## ORDINANCE NO. 2259

### **“Chapter 15.44 – INTERNATIONAL RESIDENTIAL CODE**

Figure 12  
City of Derby Deck, Footing & Post Standard

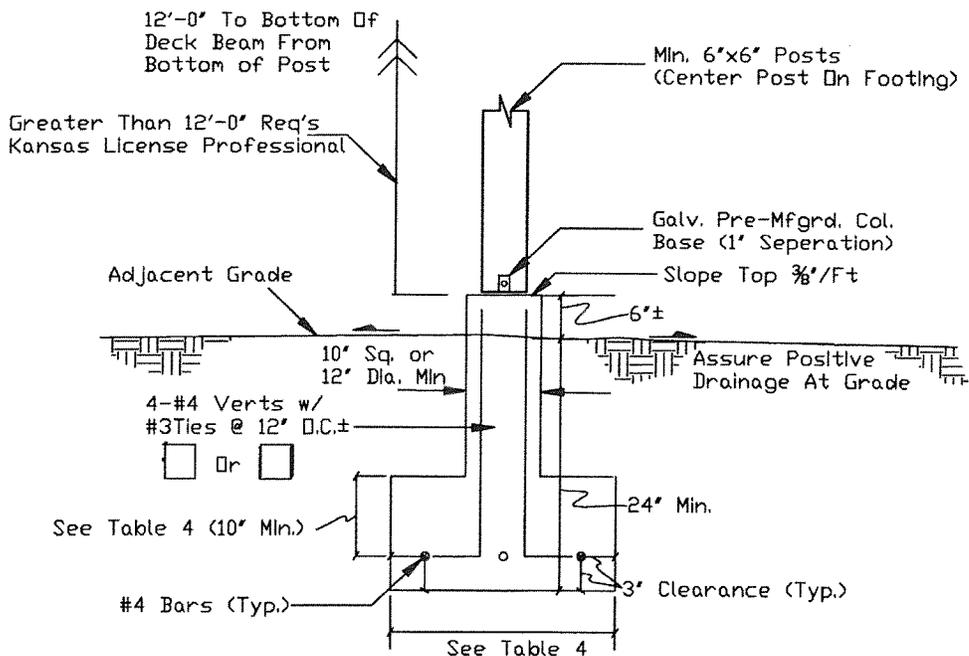
- A. Figure 12 on page 4 of the City of Wichita Standard for Residential Wood Framed Decks is replaced with Figure 12 below:
